DRAFT MOUND BRANCH TMDL
PUBLIC COMMENTS

Mound Branch
WBID # 1300

Bates County, Mo.

Subject: Draft Mound Branch Total Maximum Daily Load Report

Figure 1. Calibration run. Sensitivity runs implies insignificant differences.

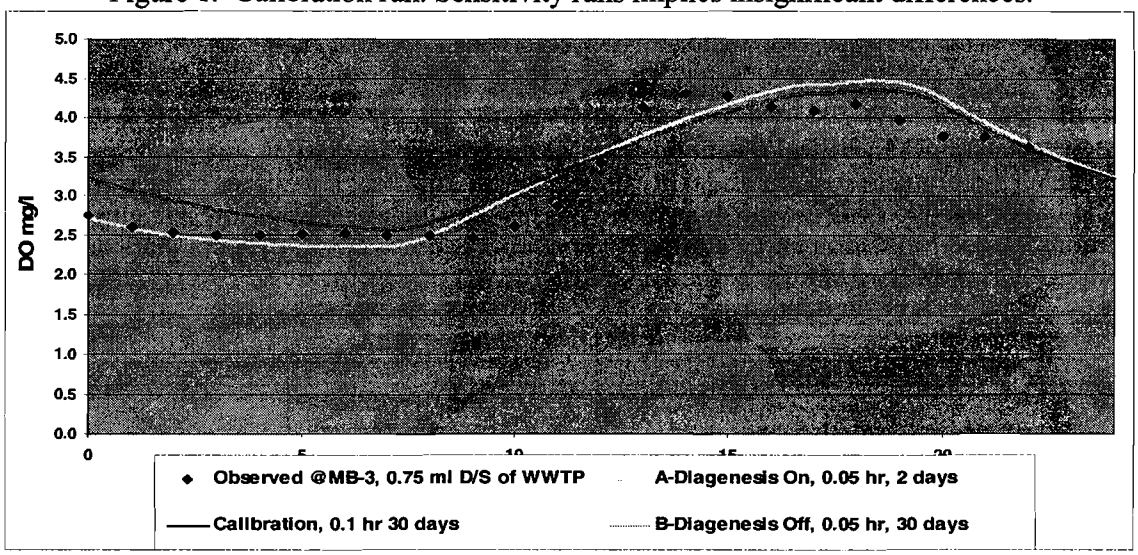
Comment #6: *Sediment Oxygen Demand is not mechanistically simulated in the TMDL model.*

The purpose of the TMDL model allocation run is to establish WLAs for CBOD and nutrients that will result in attainment of WQS downstream of the City of Butler's WWTF. The model allocation run discounts the effects of SOD, hence a minimal SOD flux was prescribed. However, if the WLA results are desired to be more conservative, mechanistically modeling the SOD would likely result in more stringent CBOD limits, lower than what is indicated in the TMDL. Recalibration of the QUAL2K model is not necessary and would not change the results of the analysis.

A 30-40 percent SOD bottom coverage is a less conservative assumption. What is described in the 2003 water quality report is the stream condition at the sampling site near the U.S. Highway 71 bridge crossing approximately 1 mile below the City of Butler's WWTF. Results of additional sensitivity analysis are shown in the following figures:
